MEMORANDUM

To: CRA Board
From: Alexandra Levering and Fabiola Alikpokou
Date: November 17, 2021
Re: Residence Inn Open Space Proposal

DESIGN REVIEW PROCESS & COMMENTS

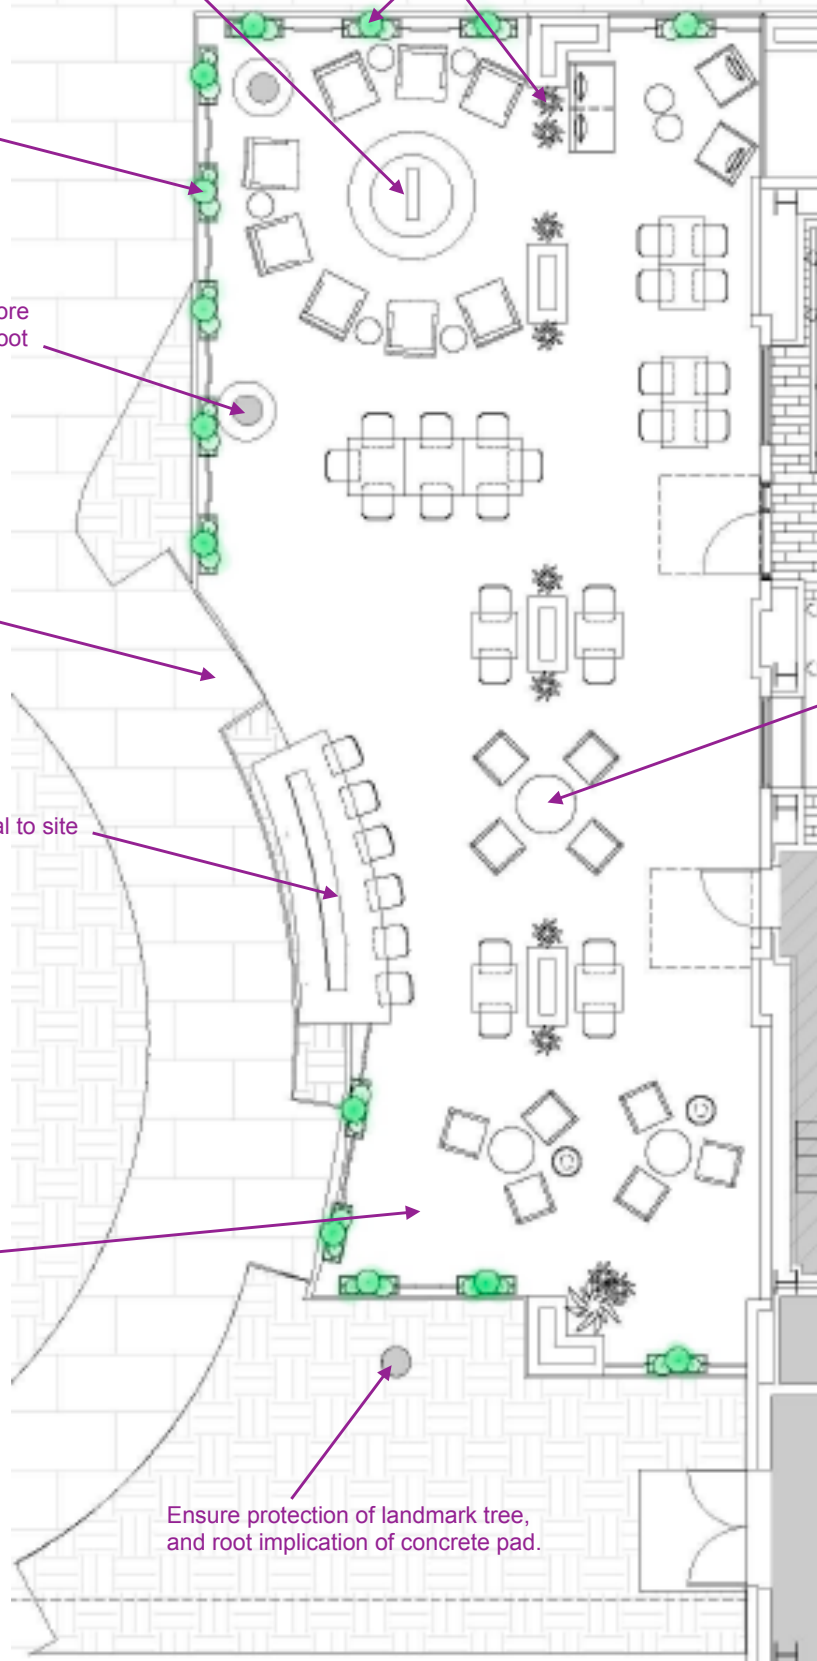
Consider maintenance of gas fire features during the day while they are turned off.

Real Plants

Movable to relocate during the day

Provide sufficient root protection for existing trees. Likely need more space around trunk, and study root impacts of installing surface.

Keep brick path separate from landscape design

Move more internal to site

Detail the drainage of the pad and consider using an impervious surface

Ensure protection of landmark tree, and root implication of concrete pad.

Maintain furniture for public use during the day and for all four seasons.
